Section 00 9113 Addendum No. 03

CHEVY COMMONS – PHASE 3
GENESEE COUNTY LAND BANK AUTHORITY
452 S. SAGINAW STREET, 2ND FLOOR
FLINT MI 48502

SHEET C-2.0

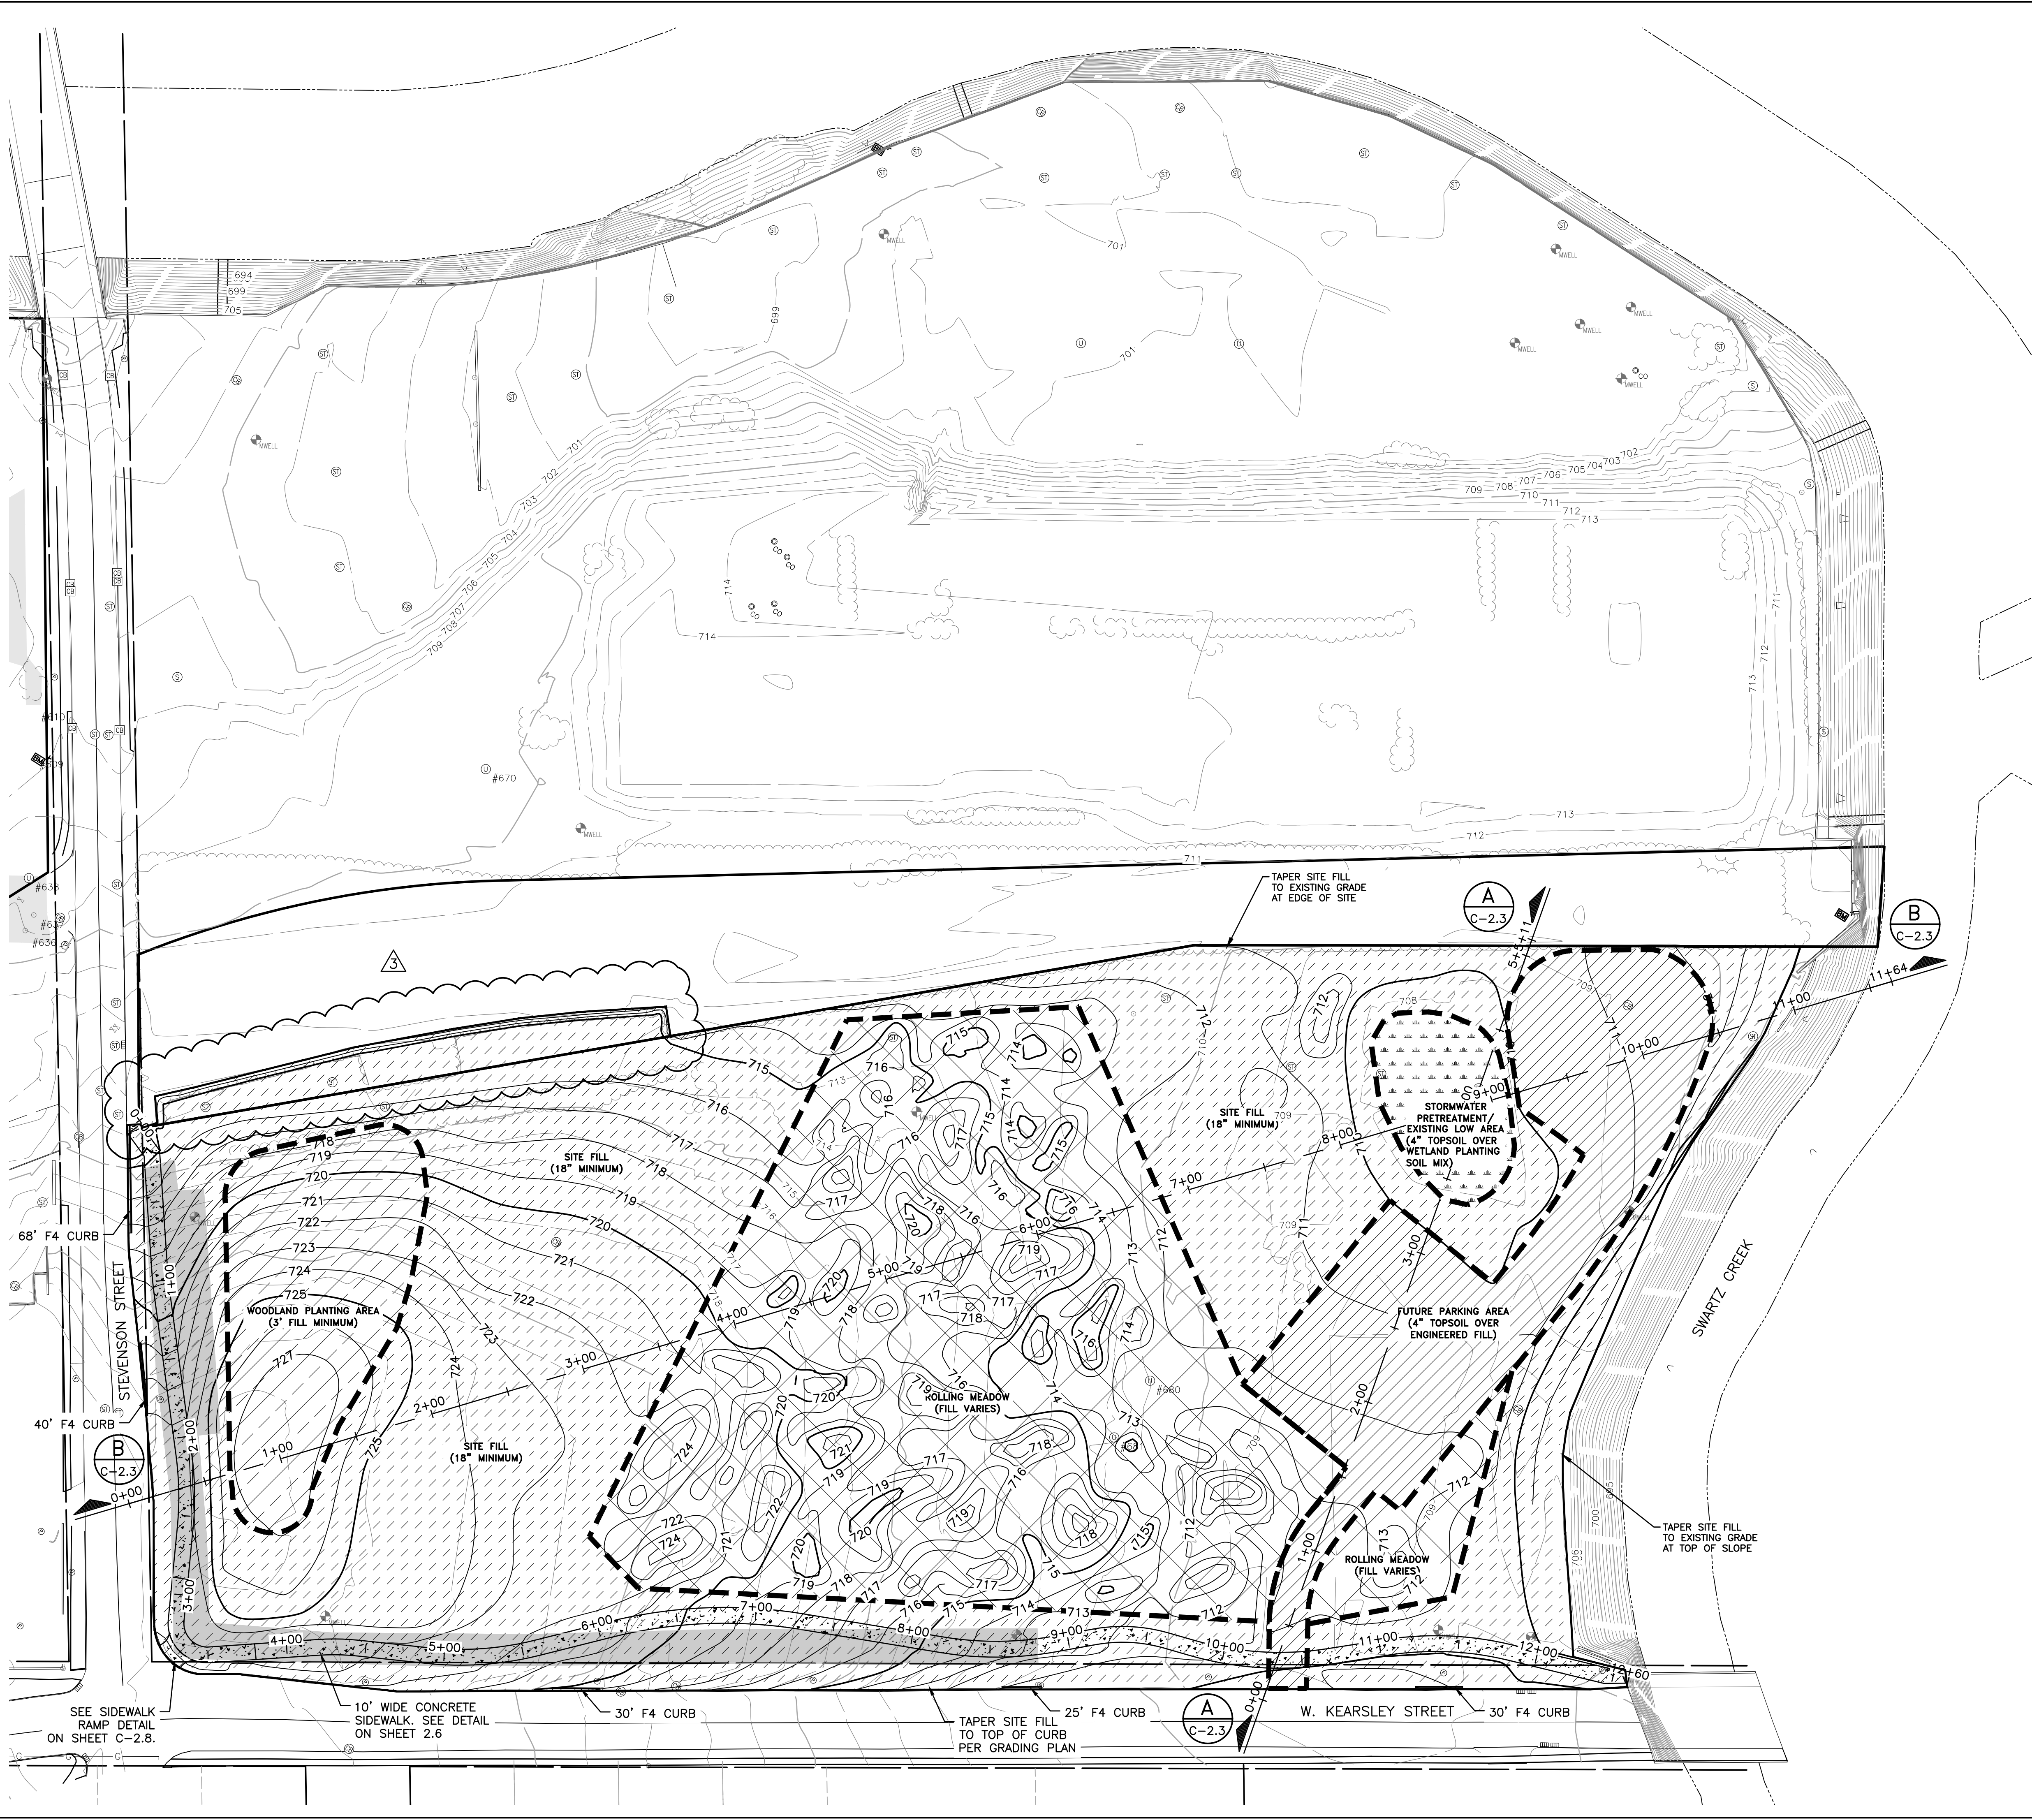
REV#	DATE	DESCRIPTION
3	6/5/17	REVISED PER APPENDIX #3
2	5/15/17	REVISED PER APPENDIX #2
		DLH
		TLH
		BY
